TOWN OF CHATHAM

TRAP DOCK RECONSTRUCTION Chatham, MA

ADDENDUM NO. 3

October 18, 2019

A PROPOSED FIER SECTION
 C-03 Scale: 1/8" = 1'-0"

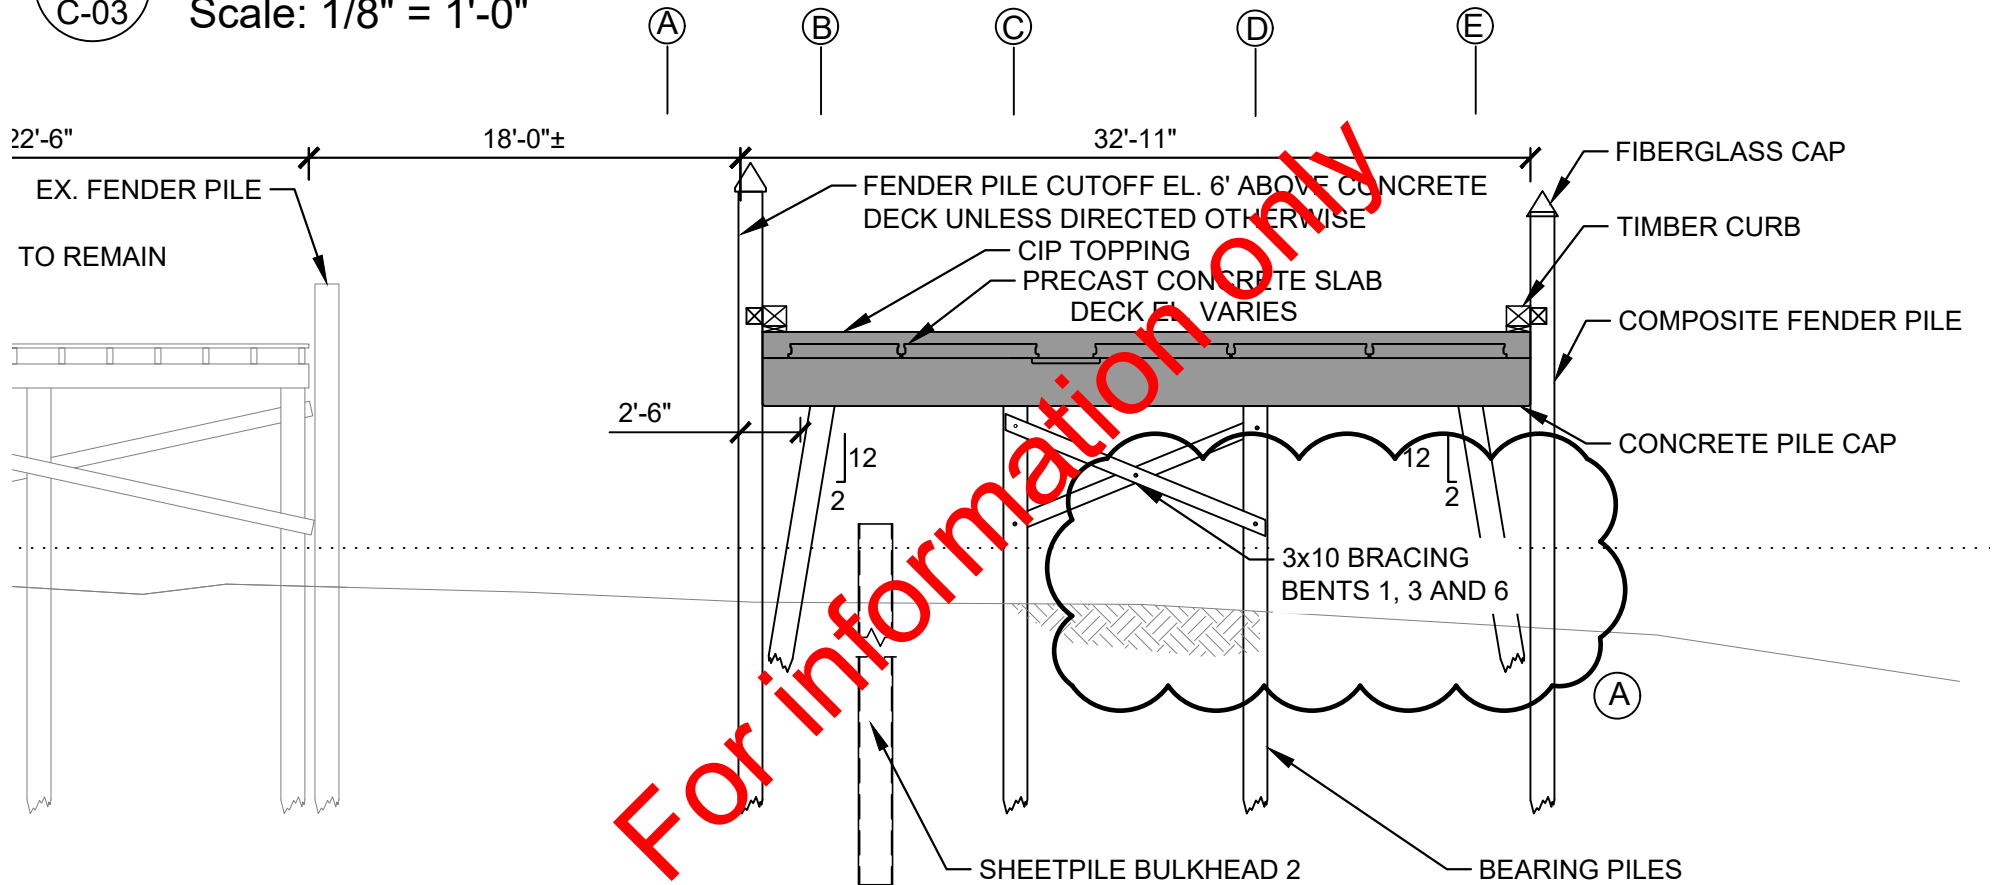
The existing electrical services to the existing building are being removed. Contractors shall refer to the Electrical drawings for requirements.
- h. The Proposed Pier Sections on Drawing C-03 show timber bracing below the deck. There do not seem to be any details or actual number of locations included in the plans. Please clarify.
All bracing shall be Tropical Hardwood 3x8 timbers. Bracing shall be installed in the North/ South Direction on Pile Rows C and D as shown on Detail C-02. Bracing shall be installed in the East/ West Direction between Pile Rows C and D on Bents 1, 3, and 6 as shown on Detail C-02.

B PROPOSED PIER SECTION
 C-03 Scale: 1/8" = 1'-0"

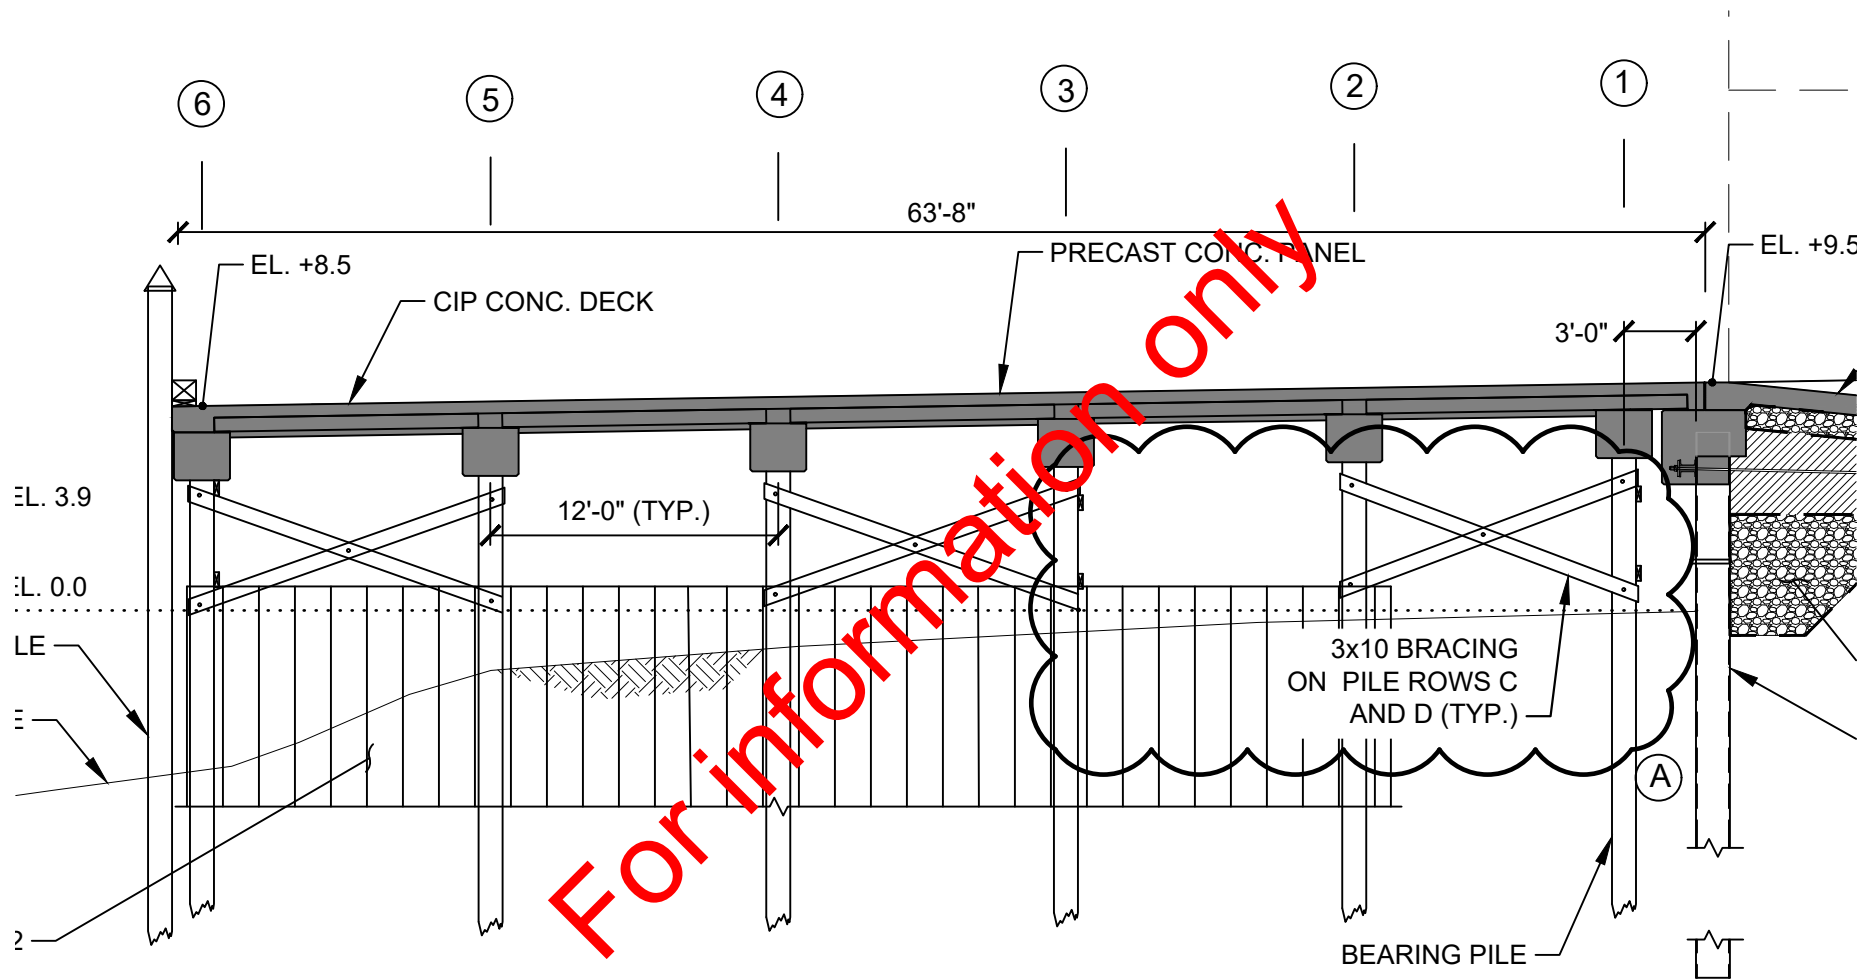
ADD – Notes to Details “B” and “C” as shown on the attached sheets.

D
C-07
CONC. PILE CAP NO. 3-6 REINF.
 SCALE: 3/8"=1'-0"

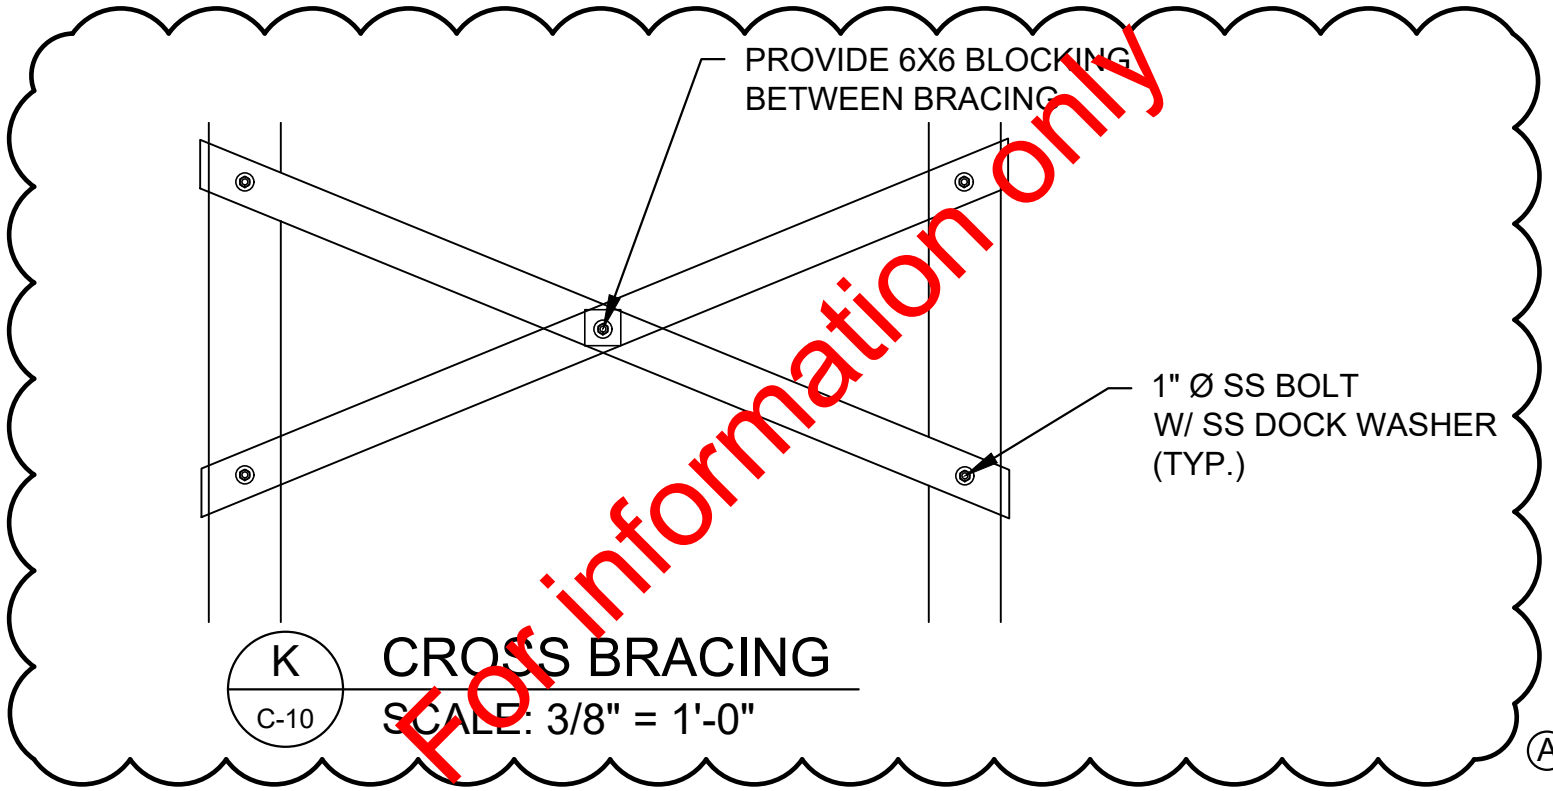
- i. Detail D on sheet C-07 shows a utility penetration running through the cast in place concrete Pile Cap #'s 3-6. What is this for? And can a detail be provided for these penetrations including block out size, reinforcement, sealing, etc.?
This is not included in the Contract. See Revisions to the Contract Drawings.

Trap Dock Reconstruction
Chatham, MA
ELECTRICAL SITE PLAN

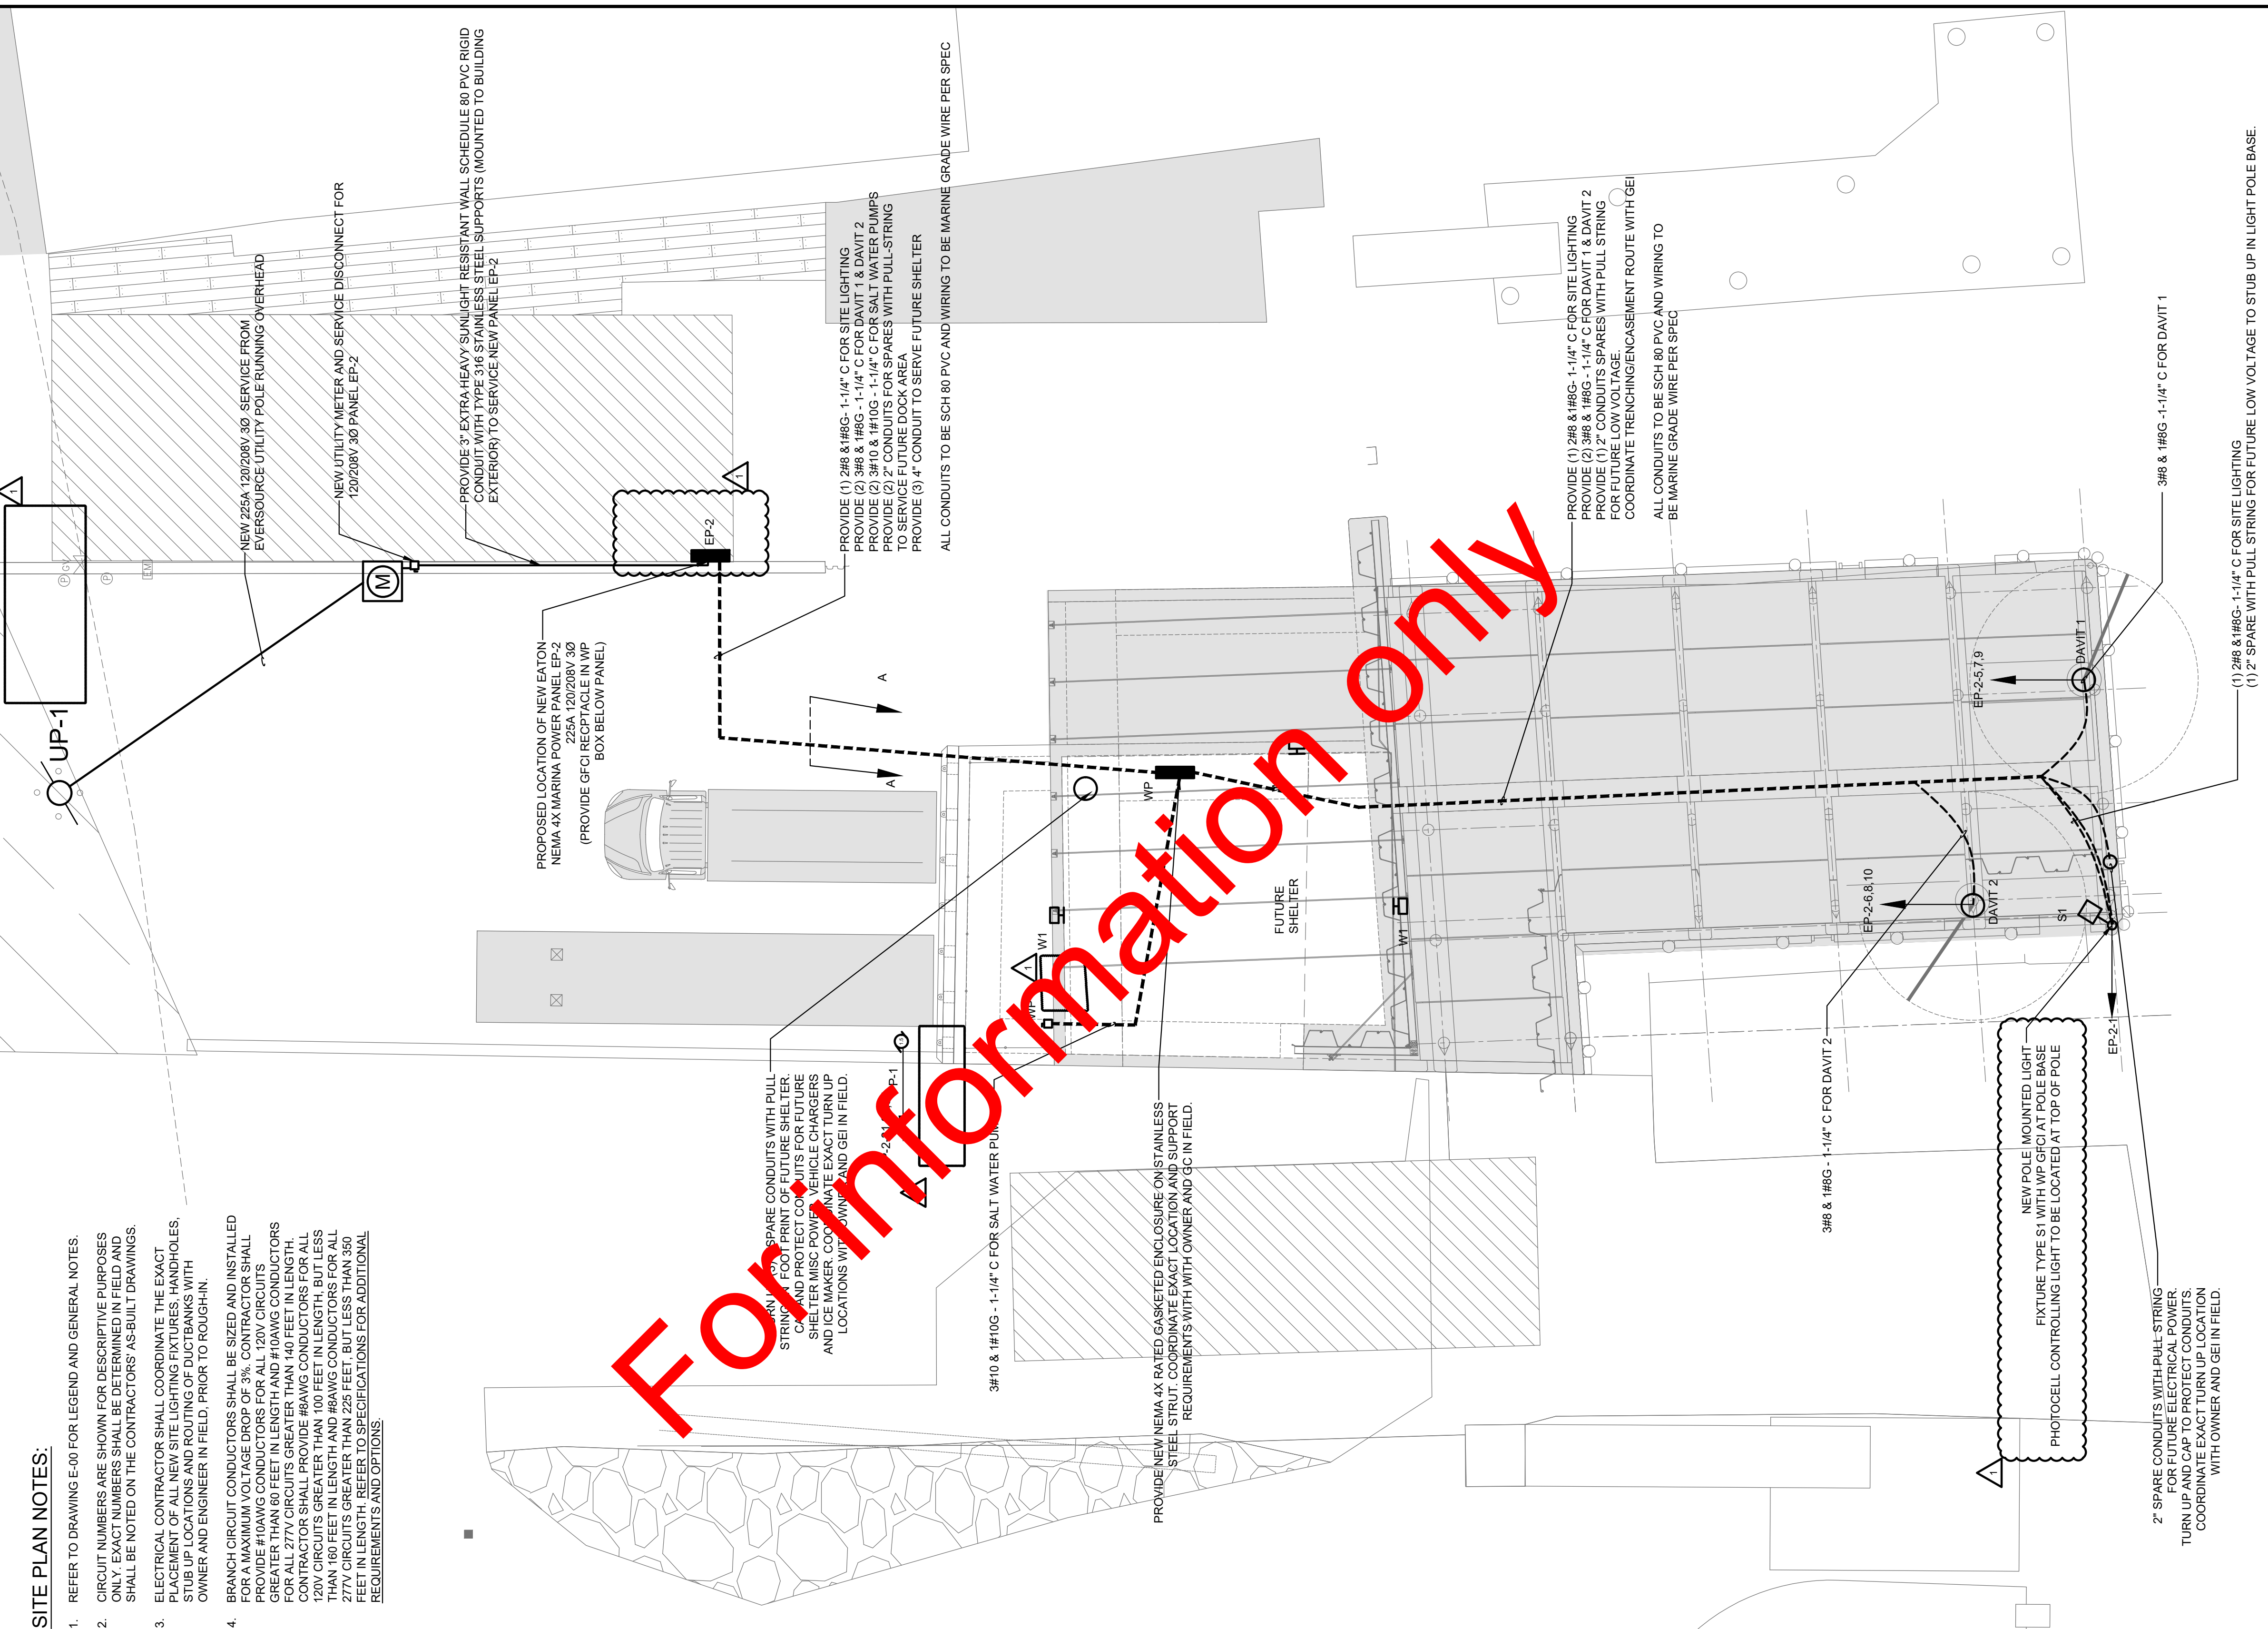
- a. On Sheet #19 there is a note stating that the existing pole is to be relocated, relocated to where?
The Town is no longer seeking the relocation of the pole. The pole will remain in its current position. See revisions to the Contract Drawings.

- b. On Sheet #19 panel EP-2 is drawn on the boat launch side of the building. Can it be located on the trap dock side?
The Electrical Panel has been relocated to the west side (Trap Dock side) of the building. See revisions to the Contract Drawings.

- e. Please verify the electrical duct bank detail "A-A" shown on drawing E-04 shall be utilized for the proposed conduit placed under the articulated concrete mat (ACB) from the existing building to proposed sheet pile wall as shown on E-03 (sheet 19 of 24).
Yes, the Contractors shall install duct bank A-A as called off on Sheet E-3 Sheet 19 of 24, under the ACB mat.

- f. Please confirm the number of electrical conduit (10 each shown) to be installed in the duct bank from the existing building to proposed sheet pile wall.
The Contractors shall install duct bank A-A as called off on Sheet E-3 Sheet 19 of 24 to provide service from the Harbormaster building to the new electric enclosure. The Contractor shall install the conduits per code to the new enclosure. The contractor shall install the conduits from the enclosure out to the services on the pier as shown on the Contract Drawings.

Sheet E-03

Replaced in its entirety. Changes are clouded
